# Lyndhurst Hall, Air Studios, Lyndhurst Road, NW3 5NG

<b>Delegated Report</b>		<b>Analysis sheet</b>	<b>Expiry Date:</b>	<b>19/02/2020</b>
<b>(Members Briefing)</b>		N/A	<b>Consultation Expiry Date:</b>	<b>02/03/2020</b>
<b>Officer</b>			<b>Application Number(s)</b>	
Nora-Andreea Constantinescu			i. 2019/6387/P ii. 2020/0382/L	
<b>Application Address</b>			<b>Drawing Numbers</b>	
Lyndhurst Hall Lyndhurst Road London NW3 5NG			See draft decision notice	
<b>PO 3/4</b>	<b>Area Team Signature</b>	<b>C&amp;UD</b>	<b>Authorised Officer Signature</b>	
<b>Proposal(s)</b>

i. Demolition of existing single storey infill, and erection of part two-storey part one storey infill glazed structure to accommodate main entrance and foyer at ground floor and dining area at 1st floor level, all in association with the recording studios.  ii. Demolition of existing single storey infill, and erection of part two-storey part one storey infill glazed structure, to accommodate main entrance and foyer at ground floor and café dining area at 1st floor level, internal reconfiguration of ground and 1st floor levels, replacement of windows with larger openings and extension to the heights of the parapet walls

7. Existing and proposed visuals showing the 1990's infill extension to be demolished and replacement infill extension

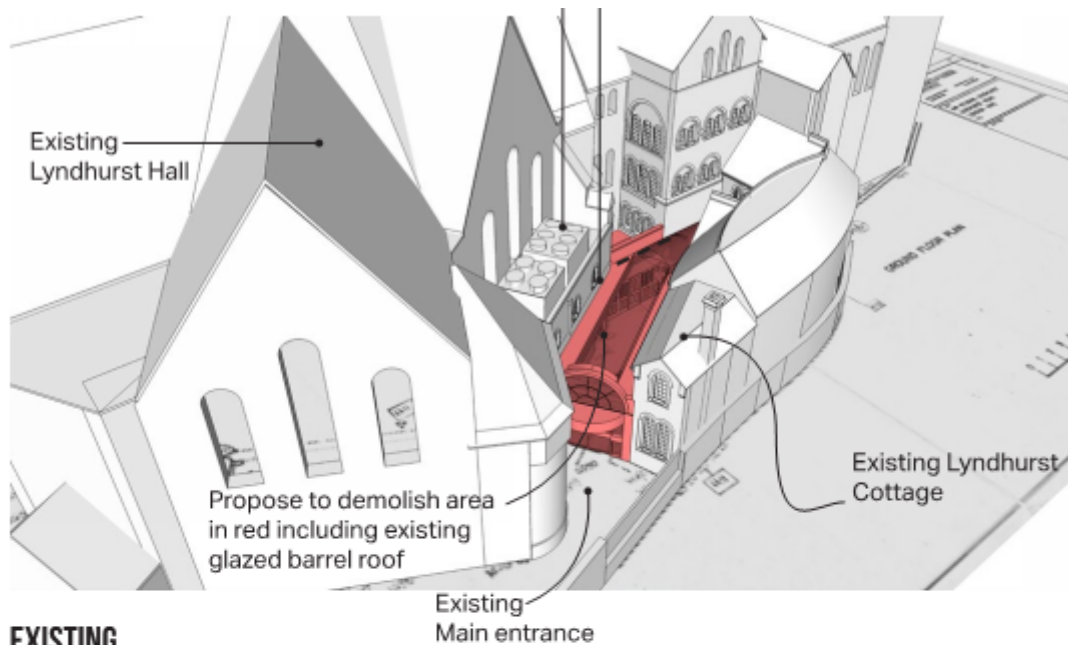
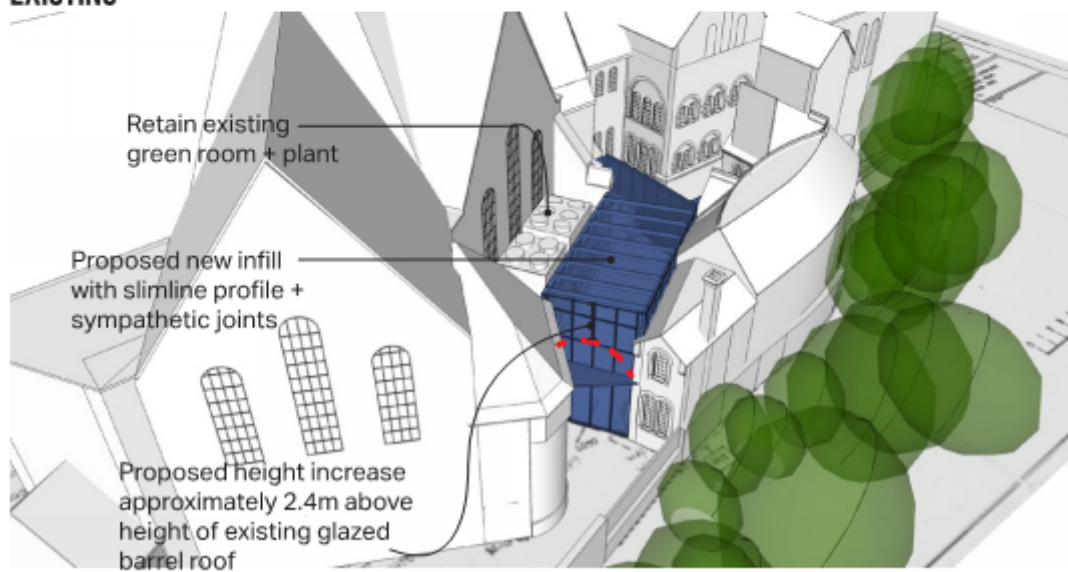
- 4.6 Along with the change of use of the premises to recording studios in 1990s, the courtyard between Lyndhurst Hall and Lyndhurst Cottage was adapted to open into a new infill structure with the role of main entrance foyer. The entrance is tucked away and not visible from the adjacent streets or any other public views. The 1990's structure has a glazed barrel vault set within a heavy timber frame, with chunky structural ribs and a subdivided clerestory detail to the upstand. The transition from the surrounding historic brickwork to the barrel vault through a solid ceiling creates a prominent internal soffit, which restricts natural light and disrupts the potential for integrating the existing historic fabric into the internal experience of the building. The structure has many failed double glazing units which compromise appearance and reduced the insulation properties of the extension. Due to its appearance, detailed design, quality and relation to the host building, it is considered that the demolition of the existing vault structure would not cause harm to the significance of the listed building and this is therefore acceptable.

4.7. The proposed extension would sit in the same location as the existing and would extend along two floors in the first section, with a height greater by 2.57m than the existing structure, and towards the rear would be one storey with the height lower than existing by 0.78m. The scale and form of the extension has been designed to respond to the different scale and massing of the enclosing historic wings, ensuring they retain visual prominence and that the extension is subordinate in both height and scale.

4.8 The extension would have a simple contemporary profile, with very shallow pitch for water dispersal, which would allow the varied roof profile of the listed building to be retained and respected. The proposed infill structure would provide a legible and distinct architectural juxtaposition between the old and new, with no physical nor visual conflict with the varying position of fenestration on the surrounding facades and so as to reconcile different floor levels. The new areas created, subject to the reorganisation of spaces over two floors, would be light filled and spacious, allowing a full appreciation of the surrounding fabric and architecture of the building through its glazed elevations and roof, preserving the significance of the listed building.

4.9 With a proposed lightweight structure the new glazed roof will provide more transparency than the existing. This will allow for an improved internal and external visual relationship between the foyer, circulation areas, dining, and surrounding buildings. The historic fabric and architectural detailing of the main building and its significance would be integrated and visible from first floor level which is not currently the case with the existing extension. The floor of the first floor within the new structure would have walk on glass along the sides to allow natural light to reach the ground floor level and allow views to the historic structures. Furthermore, the junction between the proposed glazed infill floor and the surrounding historic fabric has been carefully designed to not harm the existing historic fabric. This is considered an improvement when compared with the heavy junction resulting from the flat roof and internal soffit of the existing modern barrel vaulted structure. The proposed glazed structure would be considered to preserve the character and appearance of the listed building as well as its significance. In order to ensure high quality materials, details of the glazing finishes would be secured by condition.
